PROPOSED MIXED-USE DEVELOPMENT LOT 200
CNR. STRICKLAND AND NORTH STREET SHIRE OF DENMARK
GRAEME ROBERTSON PO BOX 140 CLAREMONT 6910

19 January 2016 - Attachment 8.1.2a

Development Application Report Proposed Two Storey Mixed Use Development

Lot 200 (3) Strickland Street,
Denmark

GROUND FLOOR LAYOUT
SCALE 1:100

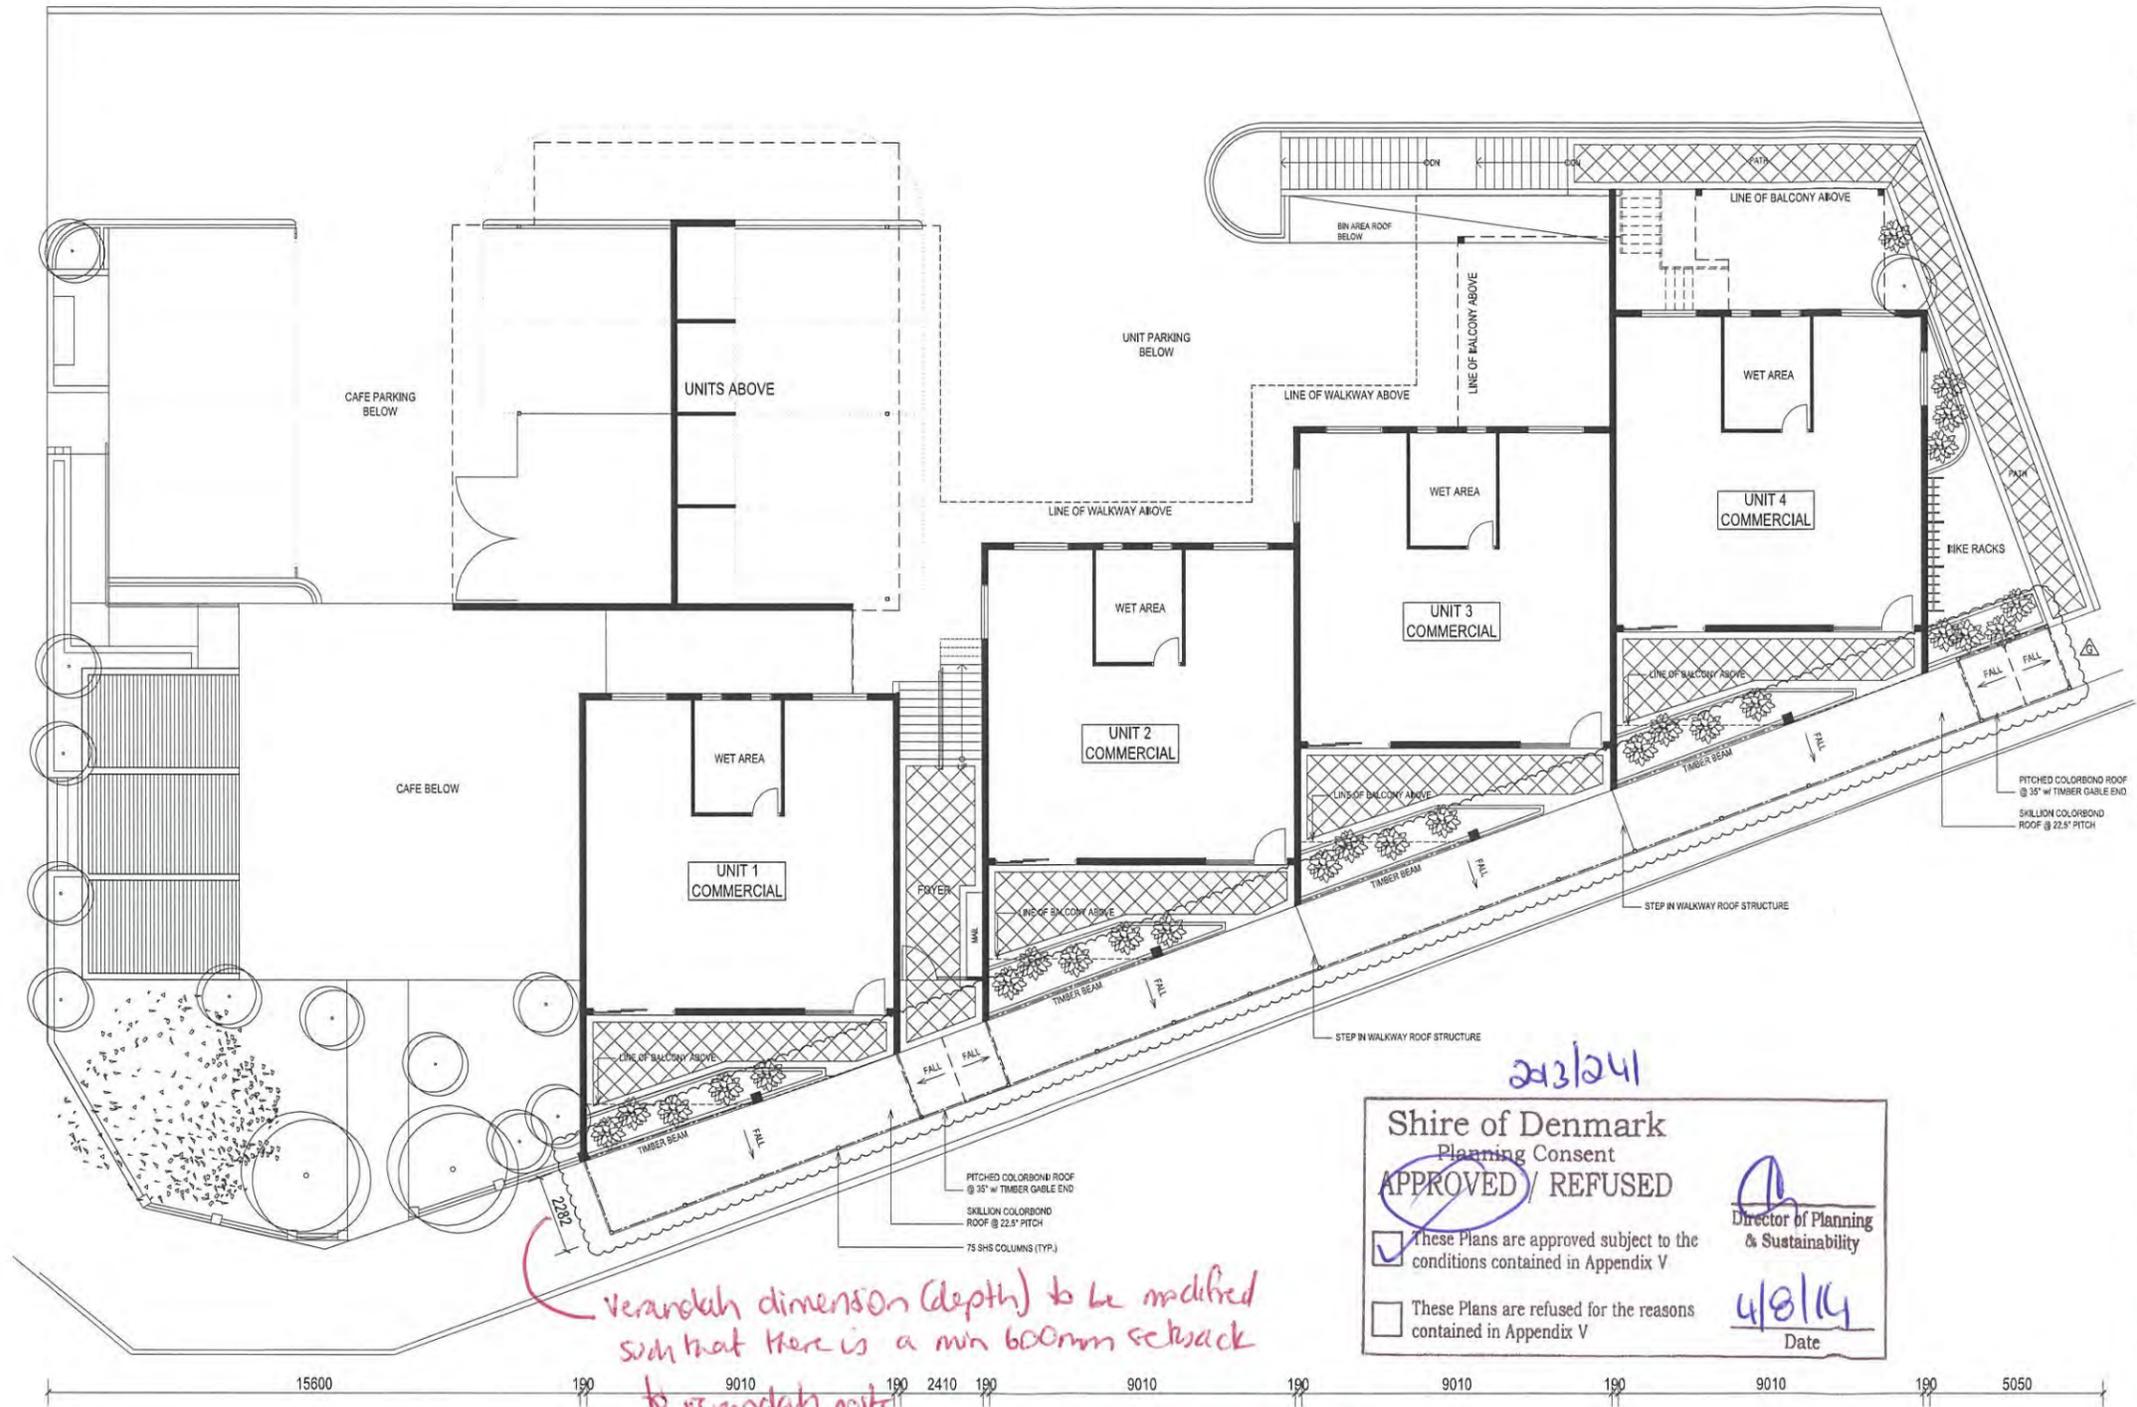
Verandah dimension (depth) to be modified such that there is a min 600mm setback to kerbside paths from the face of the kerb - noting Strickland Street footpath is only 2.28 metres from boundary line to face of kerb (not 3 metres as drawn here).

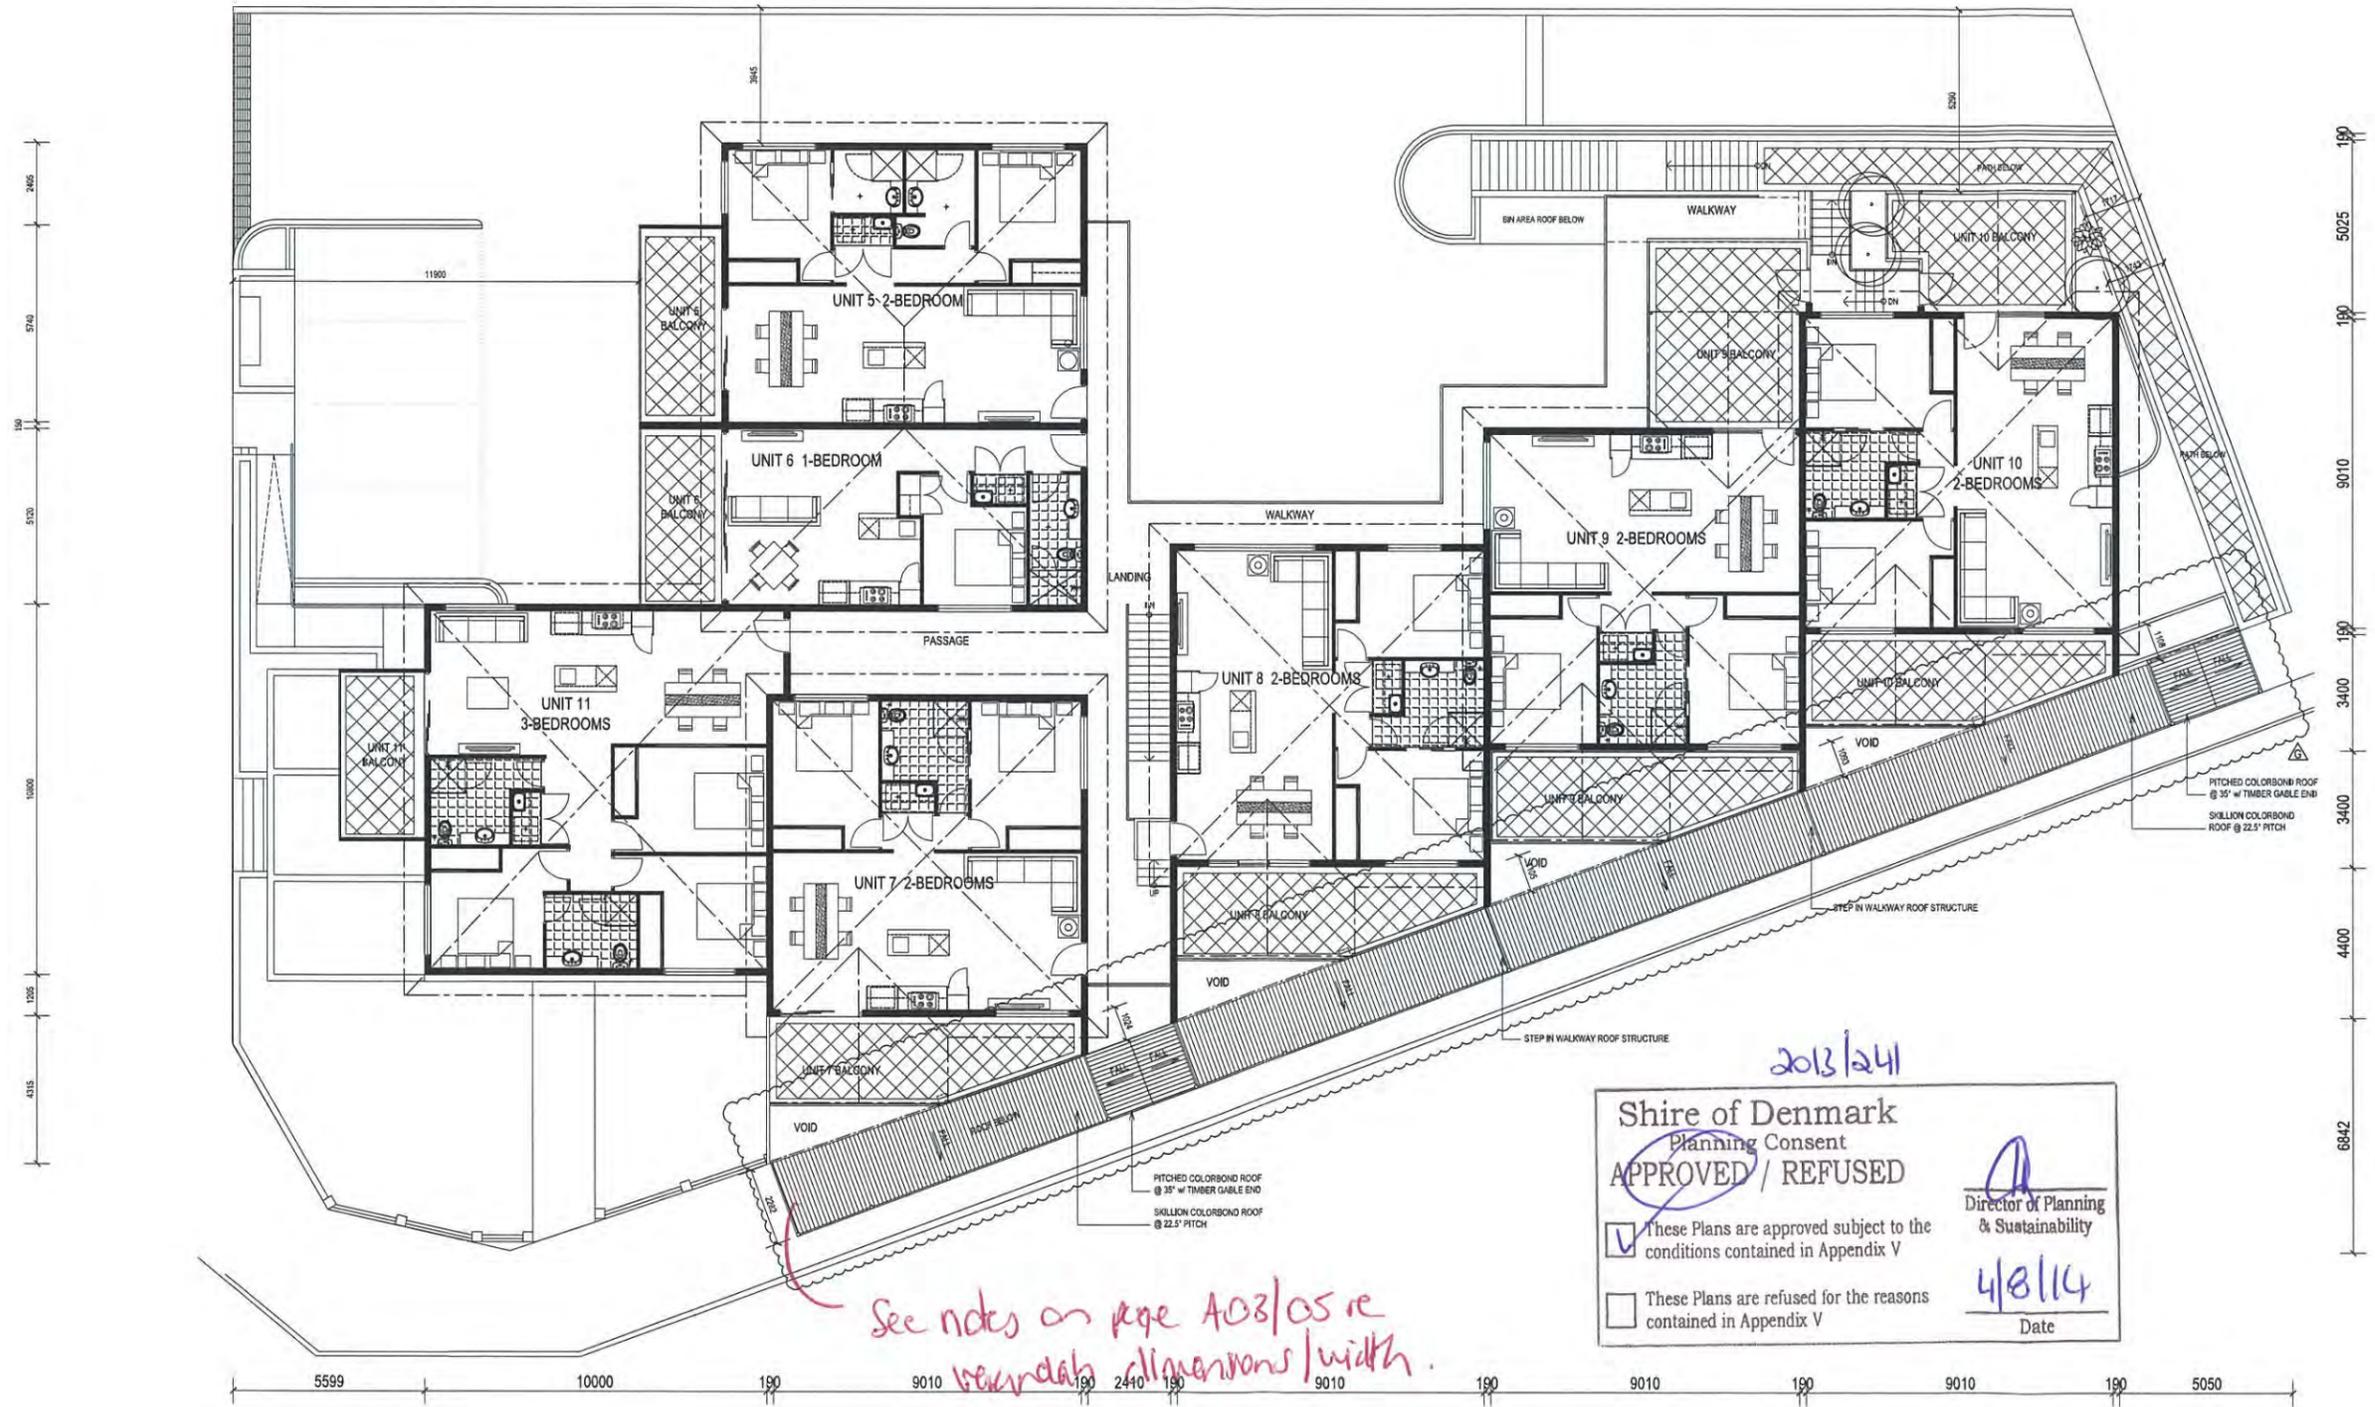
*See notes on page A03/05 re
structural dimensions / width.*

ELEVATION No. 4
SCALE 1:100

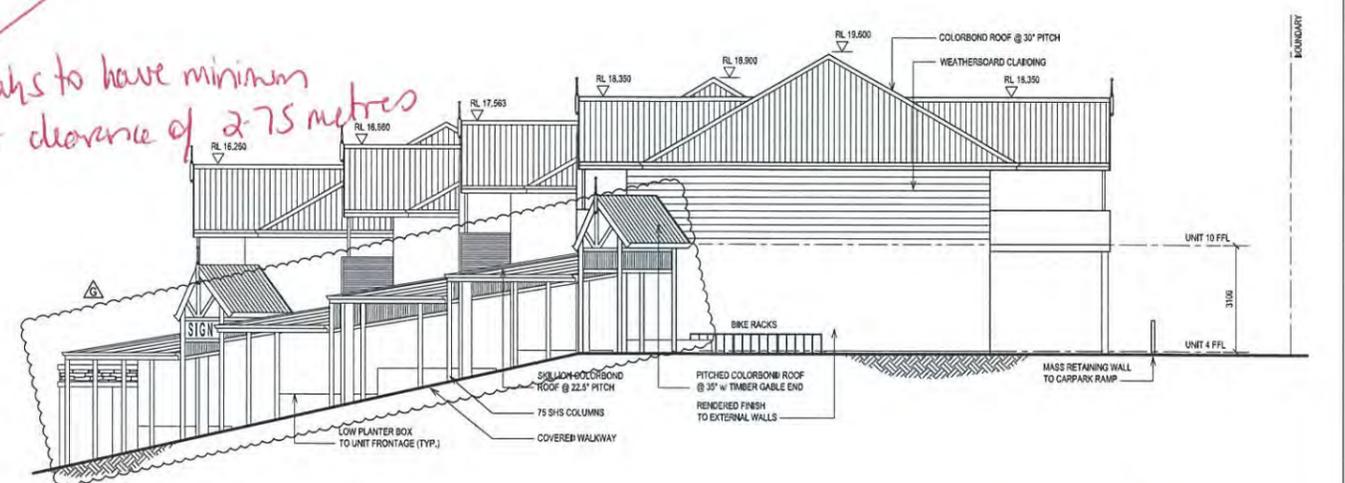
Venue has to have minimum height clearance of 2.75 metres

SITE PLAN 1:200
PARKING LAYOUT

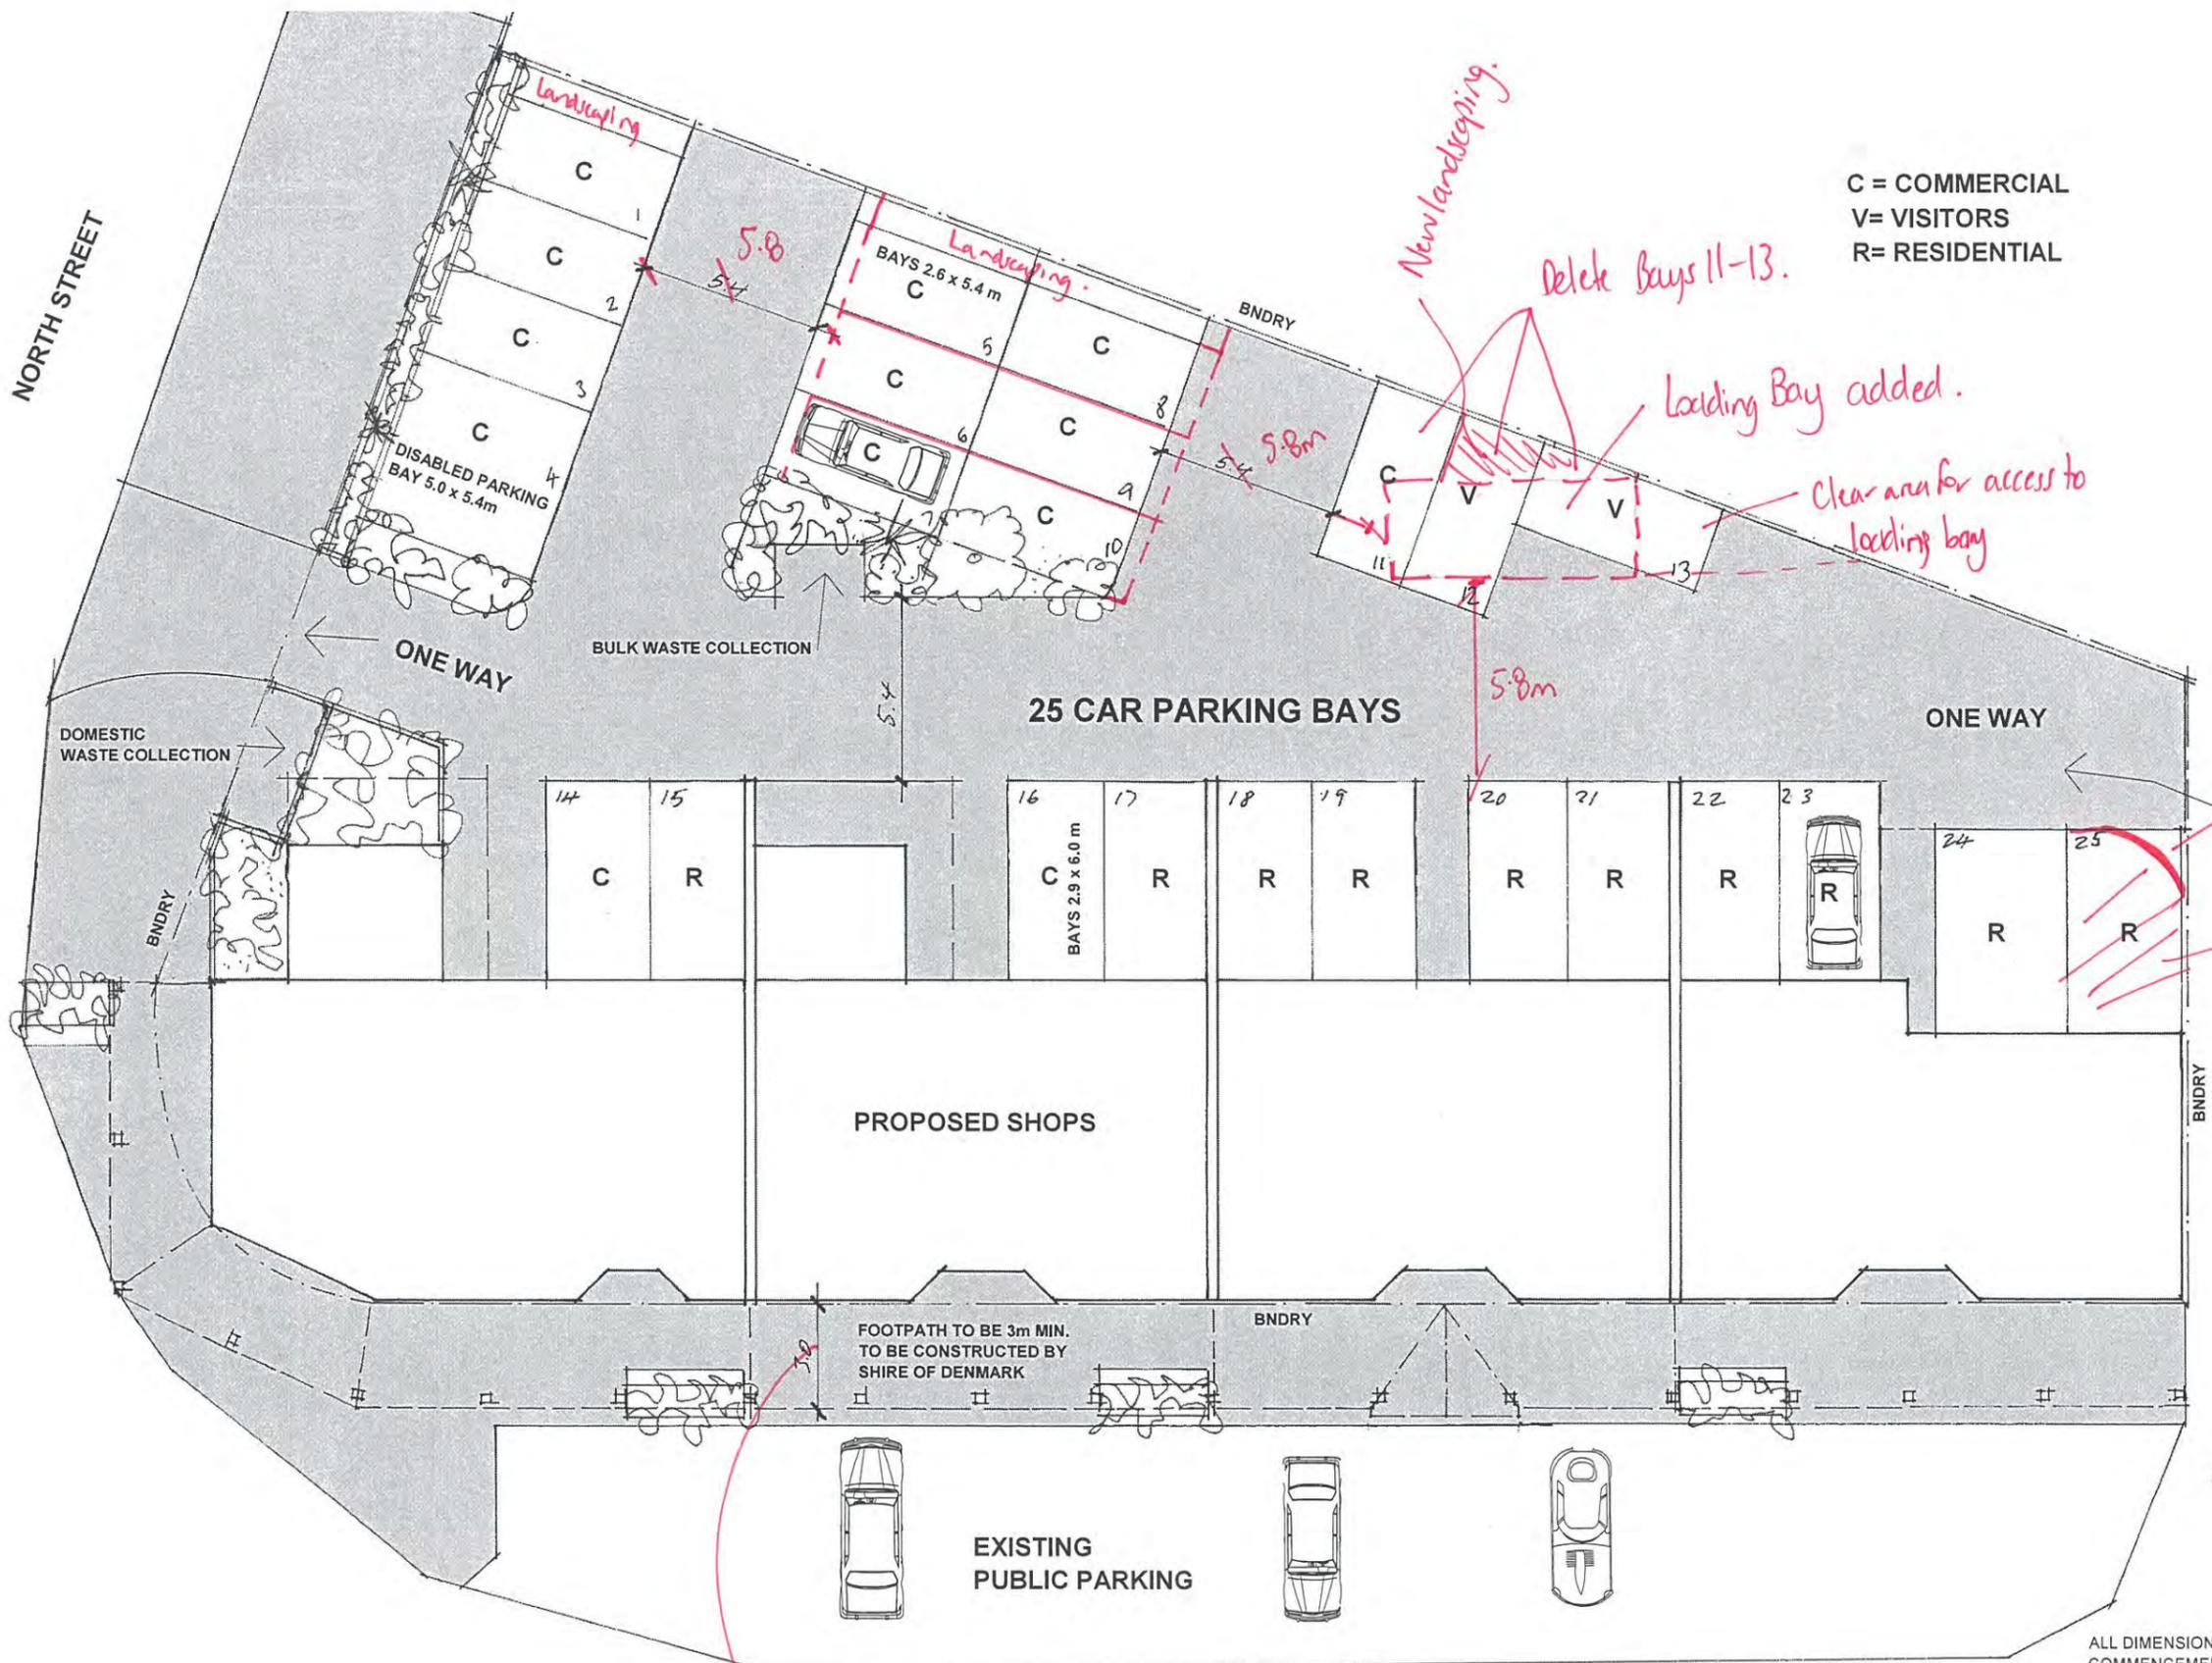
Footpath modifications and verandahs shown on this plan to be the subject of separate consideration by Council.
